Village of Arlington Heights
Plat and Subdivision Committee
Community Room, 3rd Floor
Arlington Heights Village Hall
33 S. Arlington Heights Road
Arlington Heights, IL 60005
July 22, 2015
6:30 PM

Item: 1510 E. Northwest Highway - T1507

Item: 608-614 N. Haddow Ave. - T1508

To: Plat & Subdivision Committee
Prepared By: Derek Mach, Landscape Planner
Meeting Date: July 22, 2015
Date Prepared: July 15, 2015
Project Title: Lot Consolidation for 608-614 N. Haddow Avenue
Address: 608-614 N. Haddow Avenue

SITE PLAN

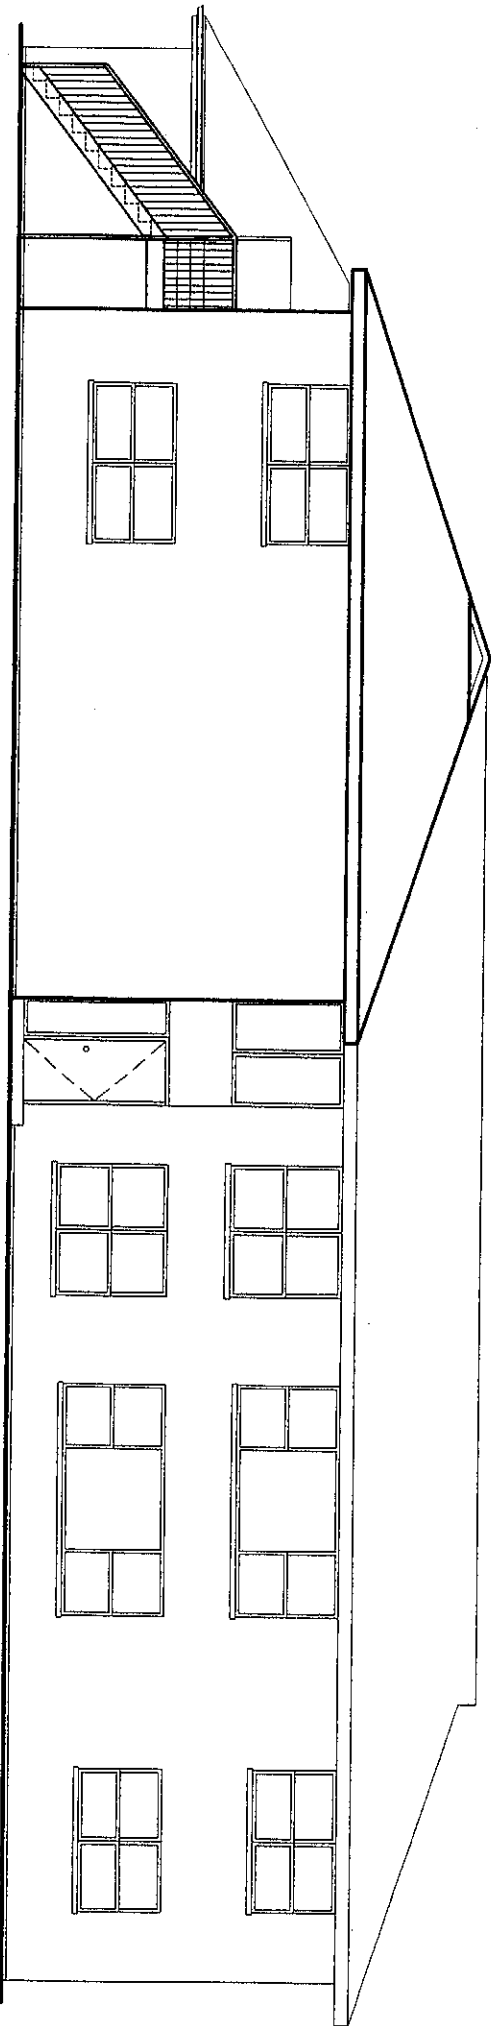
4. The west wall of the existing building faces a single family residential street. It is recommended that the stair be built within an enclosed addition to the building, or otherwise screened from view. A different configuration for the stairway should be considered to keep it closer to the existing building wall.

Also, per Chapter 28, the maximum building coverage for new construction is 35% which for this property would be 4987.5-sq.ft. It appears that this requirement is met with the addition of the stairs. This must be verified with the formal PC application.

Yards	Required Setback	Existing Setback	Meets/Does not Meet
Front (along Northwest Highway)	25 FT	24.5 FT	NO
Rear	30 FT	7.39 FT	NO – Variation granted
Exterior Side (along Carlyle Place)	20 FT	14.04 FT	NO
Interior Side	10 FT (10% of Lot Width)	10 FT (This appears to be 10', a to-scale plat must be provided)	YES

PROPOSED LEFT SIDE ELEVATION

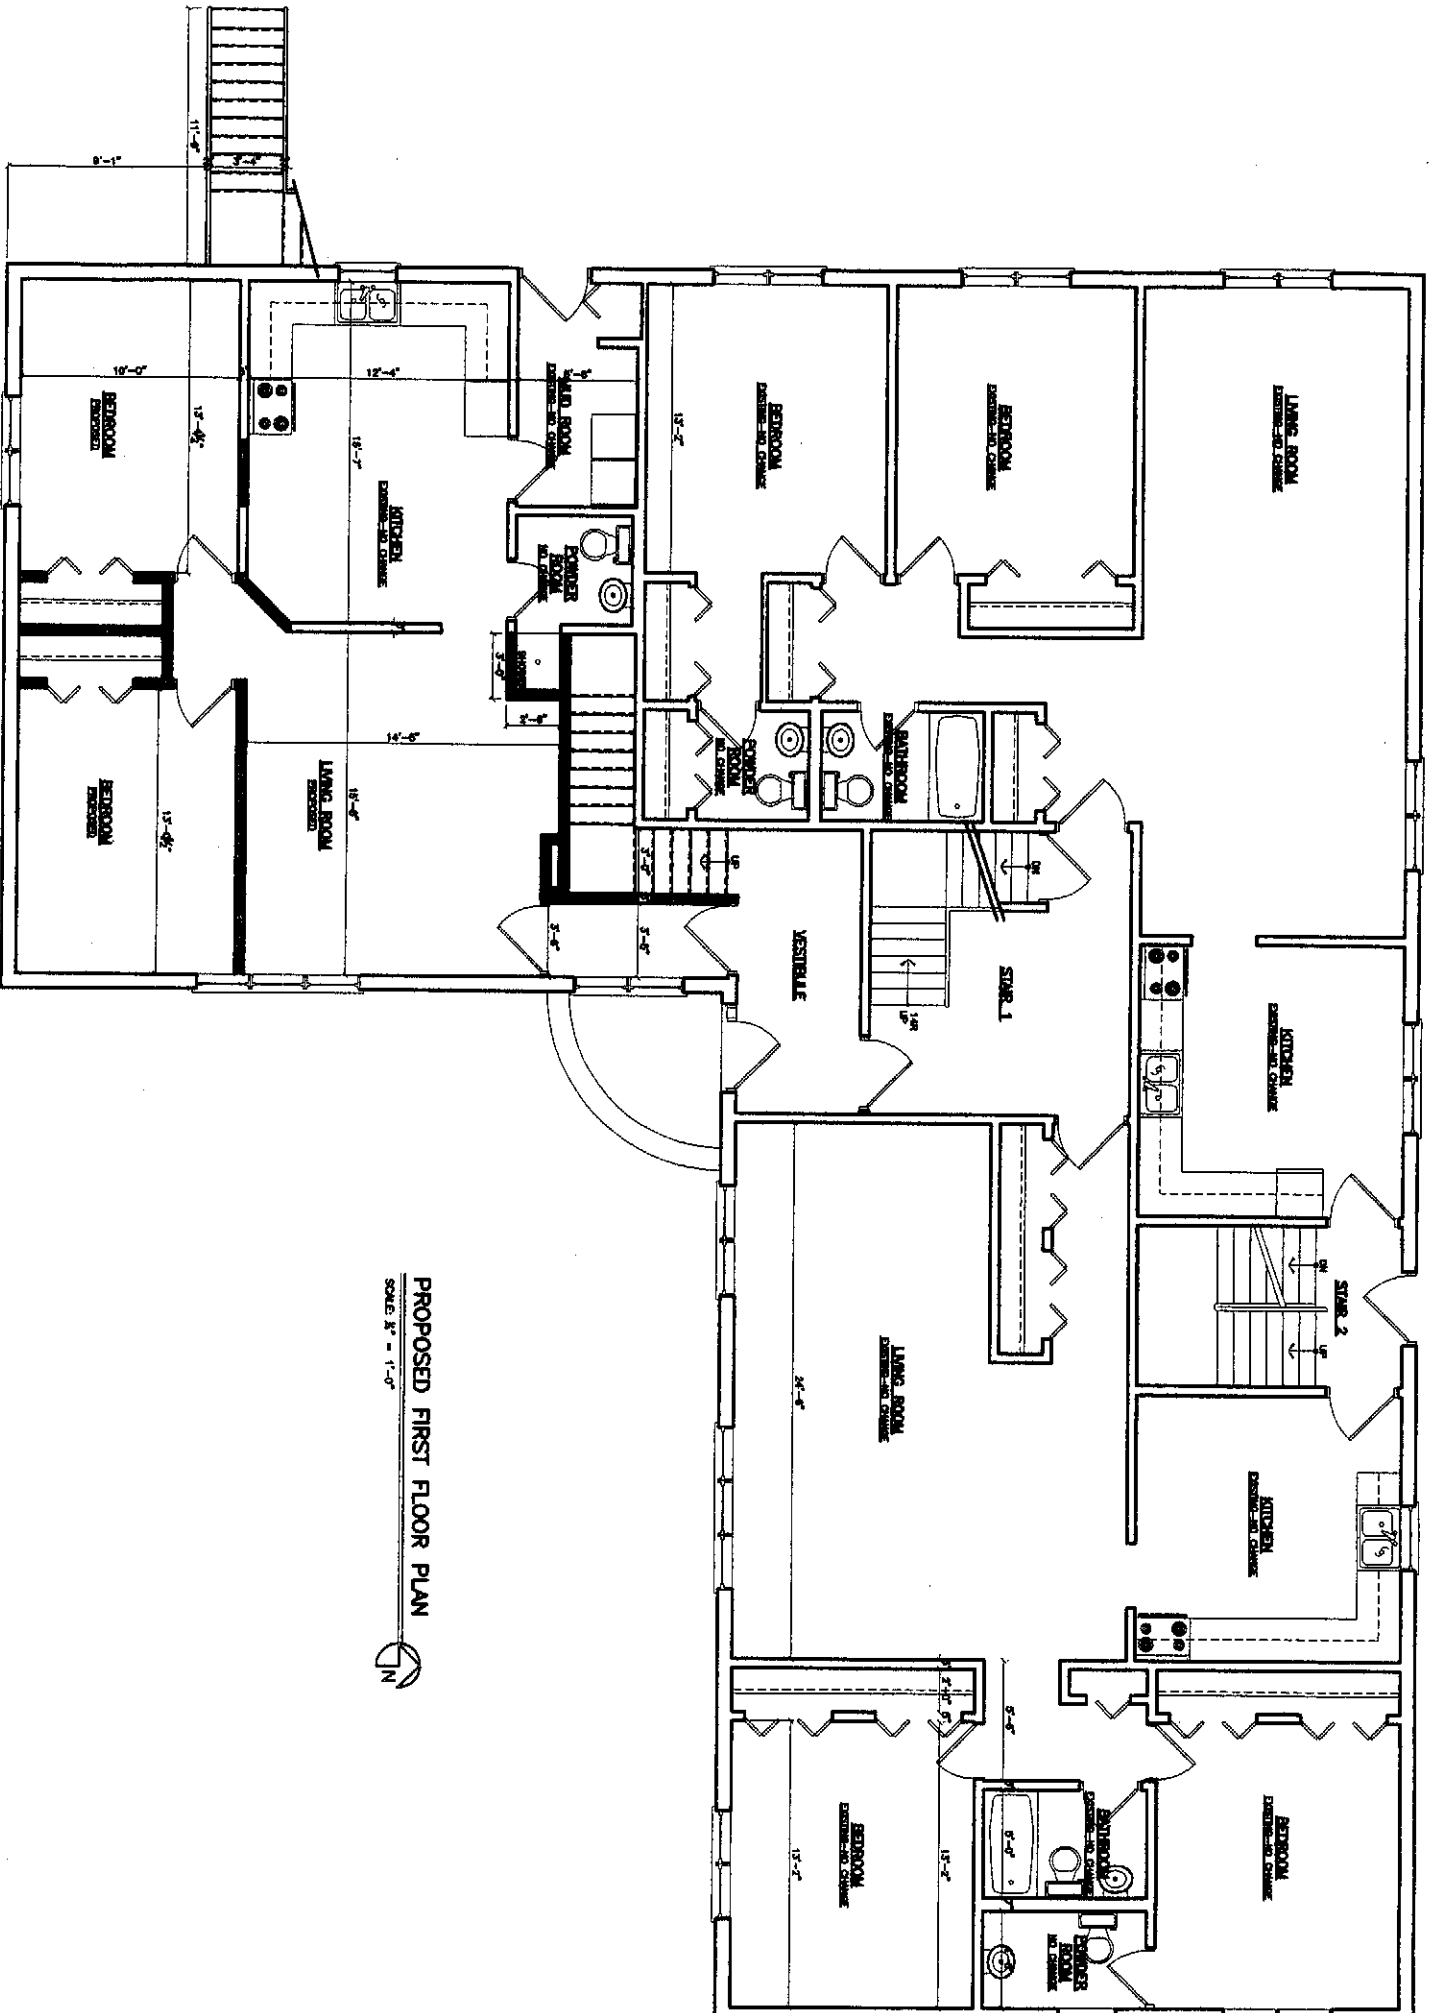
Commission Application. It is recommended that the stair be built within an enclosed addition to the building, or otherwise screened from view. A different configuration for the stairway should be considered to keep it closer to the existing building wall.

**ALTERATIONS AND ADDITION FOR
THE KURZYNSKI RESIDENCE**
614 N. HADDOW AVE.
ARLINGTON HEIGHTS, ILLINOIS

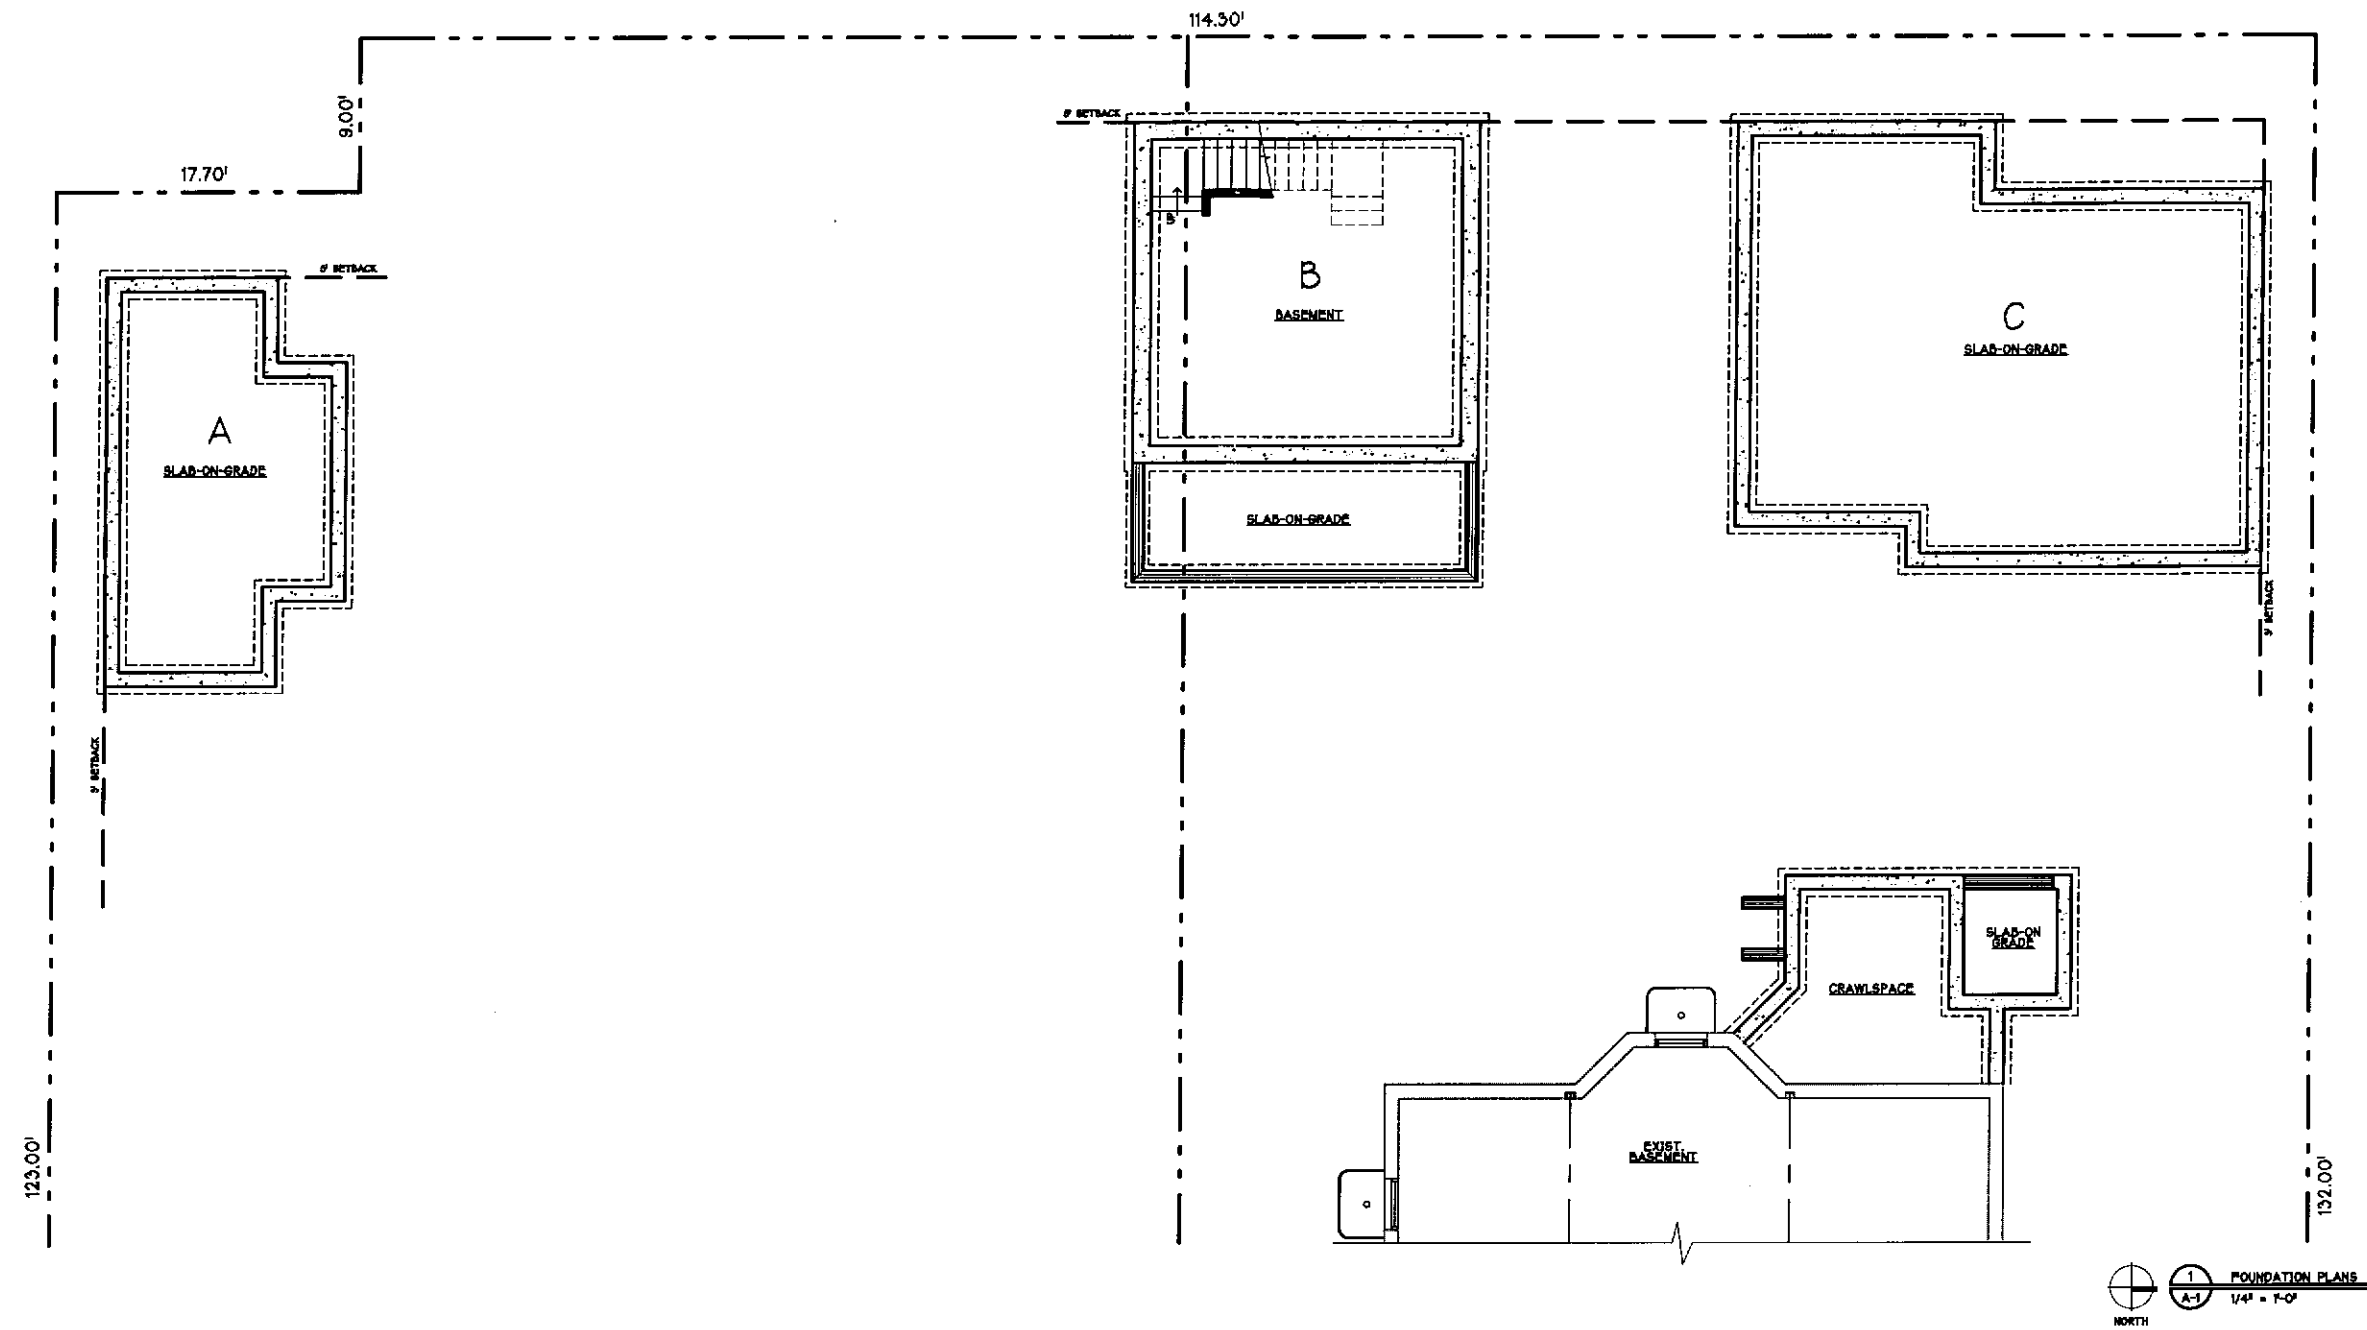
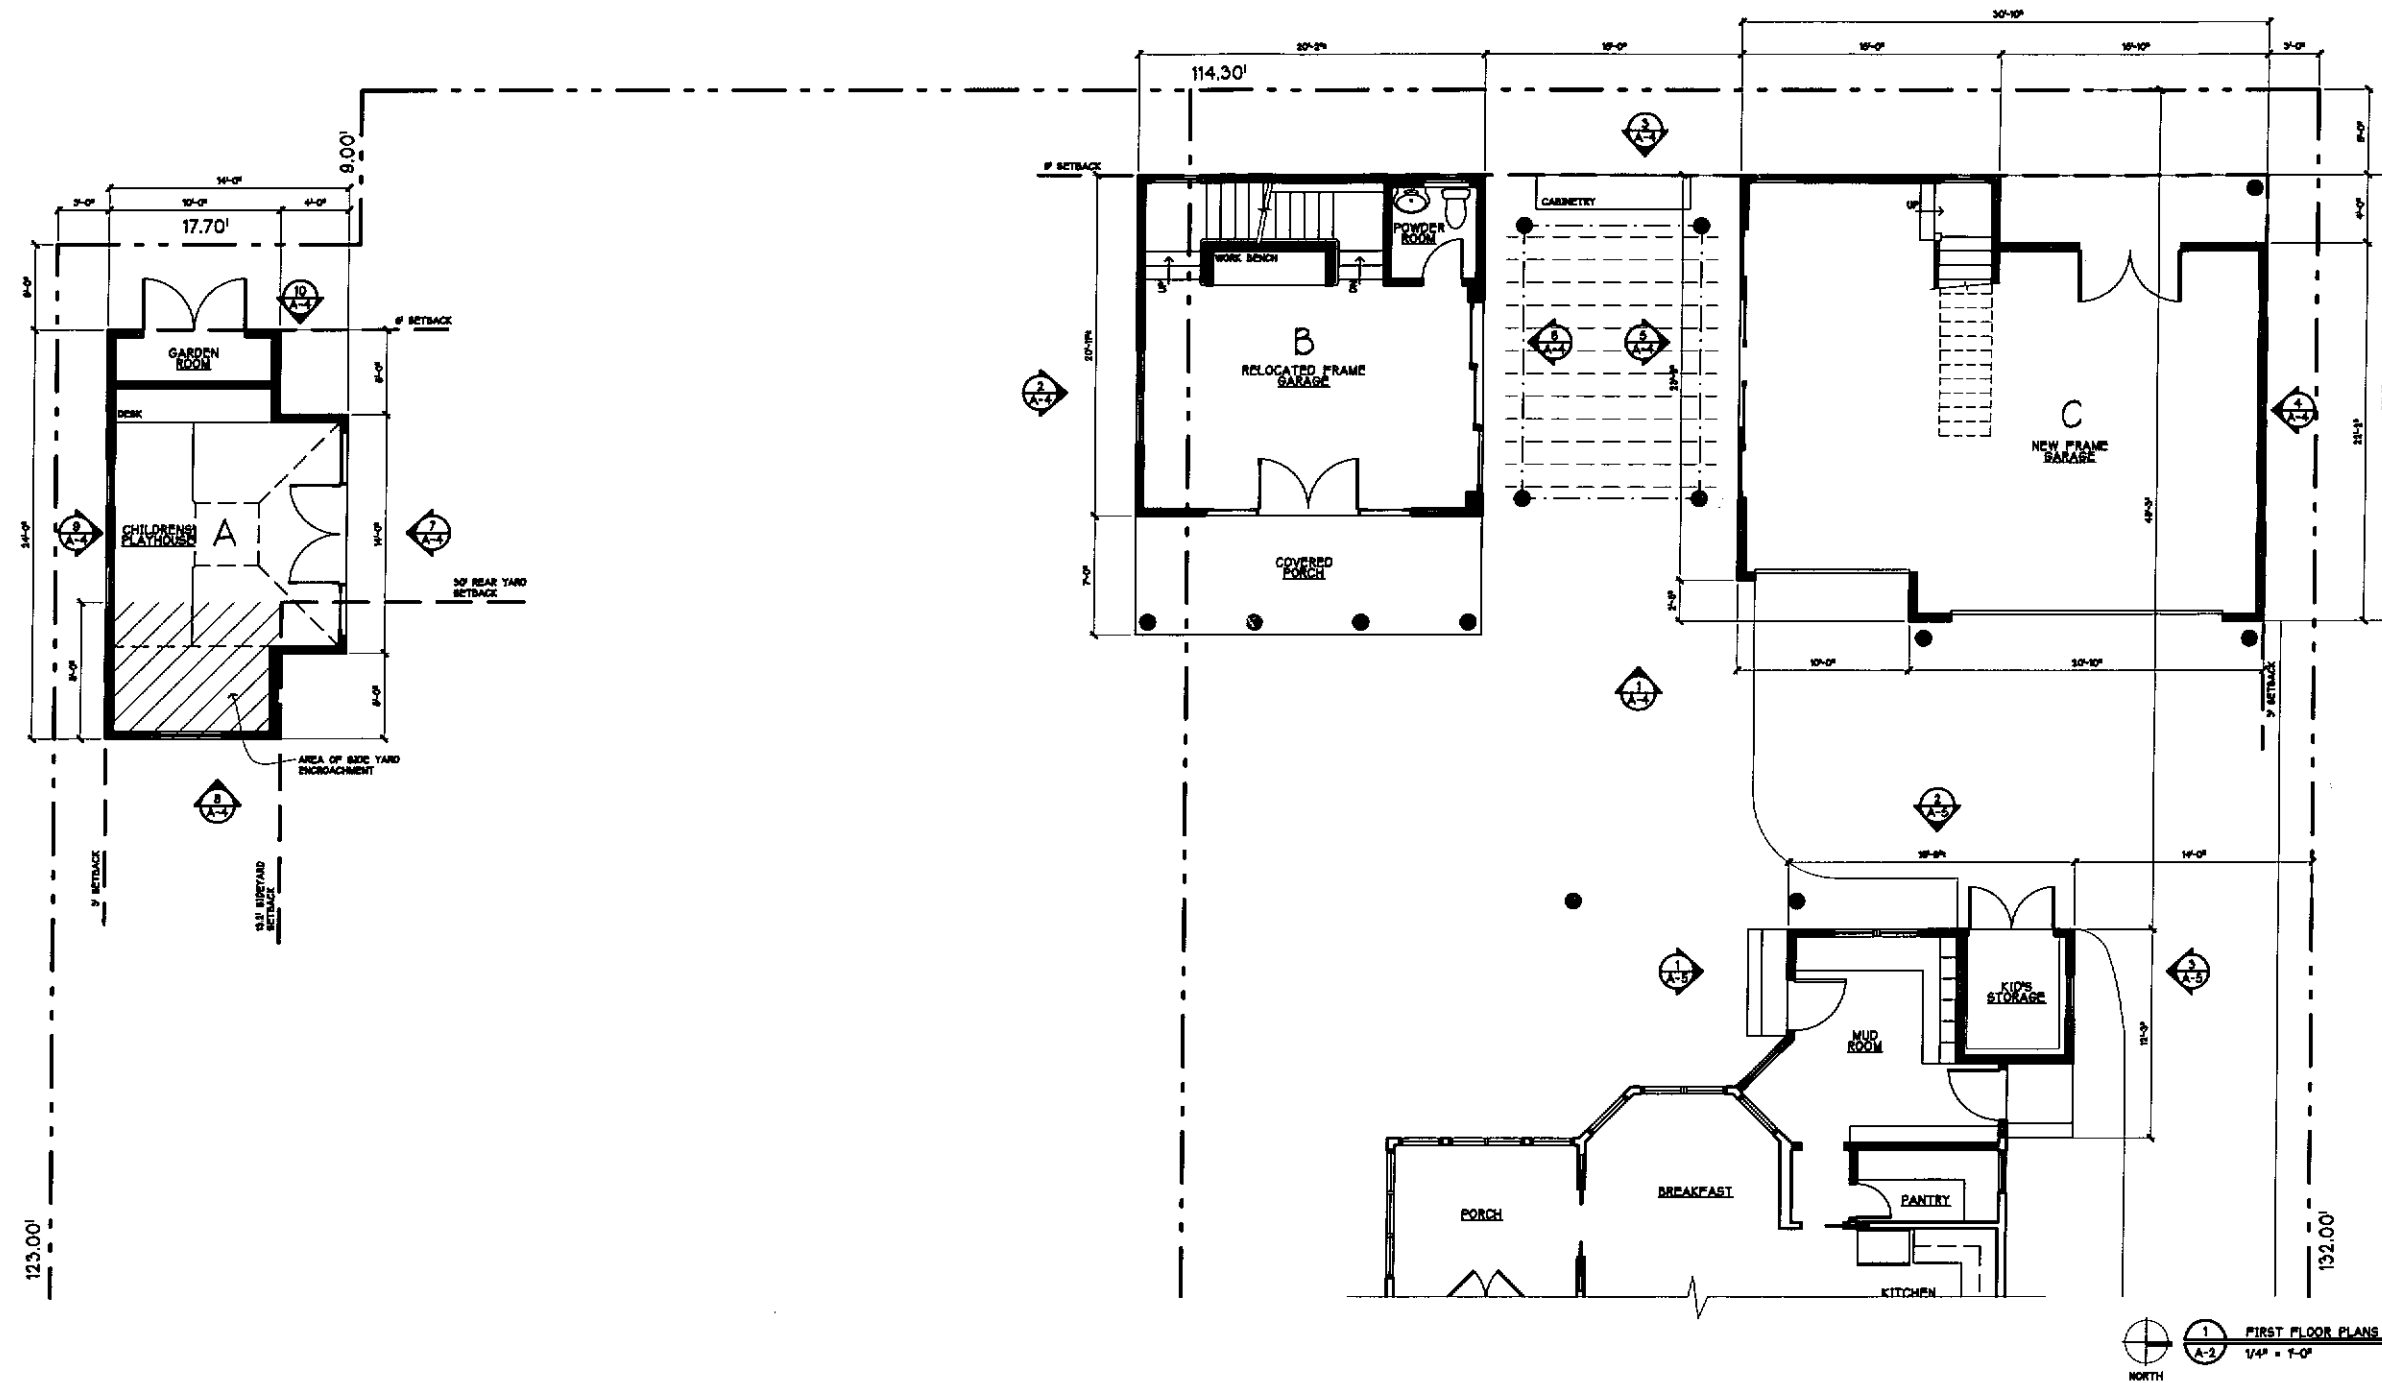
5. Identify what the basement will be used for that is shown for accessory structure 'B'.
6. Provide justification for the height variations.
7. Provide landscaping along the west property line to help buffer the three proposed accessory structures.

5. Identify what the basement will be used for that is shown for accessory structure 'B'.
6. Provide justification for the height variations.
7. Provide landscaping along the west property line to help buffer the three proposed accessory structures.
